# Access Compliance Report

## Public Rights-of-Way

### (Pedestrian Signals)

Intersection ID: N/A	Main Street:	Cross Street: N/A	Location: N/A
ADA ID: BD5B45955259	Signal Type: One Push Button-Non APS	Overall Compliance: No	Severity Score: BTN 1: N/A BTN 2: N/A No BTN: N/A
Codes/Mitigation Info/Possible Solution		Field Measurements/Component Compliance

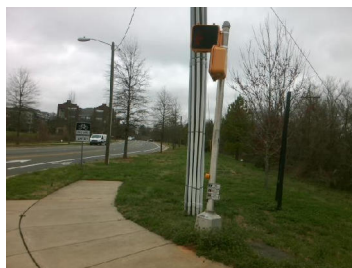
Possible Solutions: Replace Signal Push Button With APS Button on New Post. Remove & Relocate Sign.

PROW/ADA: TMUTCD 4e.08, R404.7.3, R404.7.2
